SECTION 4.55
APPLICATION

CLIENT: NIGRO RESIDENCE
JOB No: 21-108
DATE: 24/04/25

REV: D
SHEET: CC02 SITE PLAN/ANALYSIS
STAGE: DEVELOPMENT APPLICATION

13 FERNHILL STREET, HURLSTONE PARK

GA - WEST ELEVATION (STREET)

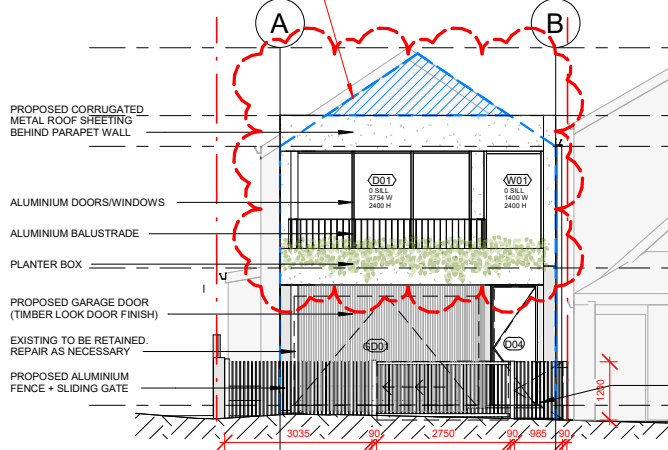
BLUE DASHED LINE
INDICATES FOOTPRINT OF
APPROVED DA. BLUE HATCH
AREA INDICATES
REDUCTION IN HEIGHT

GA - SOUTH ELEVATION

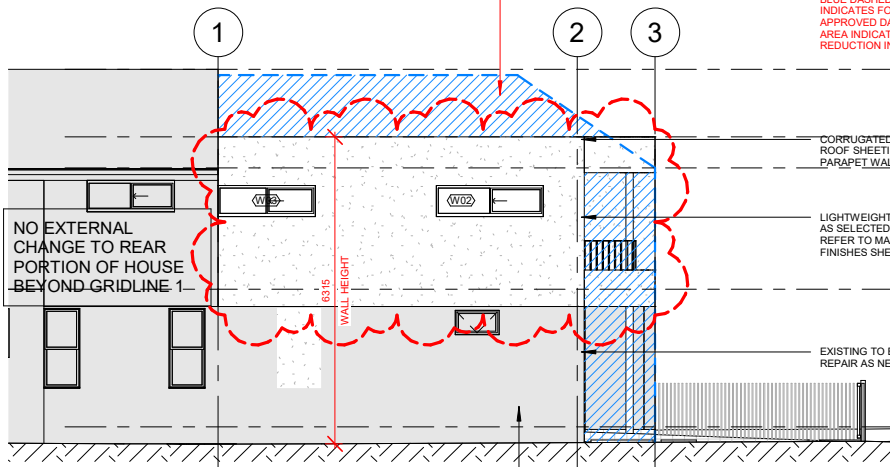
BLUE DASHED LINE
INDICATES FOOTPRINT OF
APPROVED DA. BLUE HATCH
AREA INDICATES
REDUCTION IN HEIGHT

GA - NORTH ELEVATION

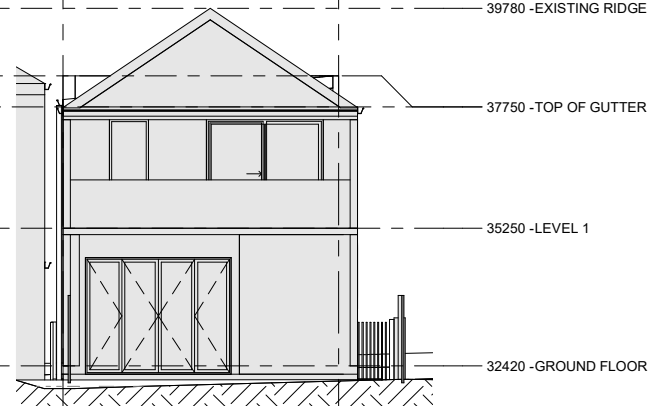
BLUE DASHED LINE
INDICATES FOOTPRINT OF
APPROVED DA. BLUE HATCH
AREA INDICATES
REDUCTION IN HEIGHT
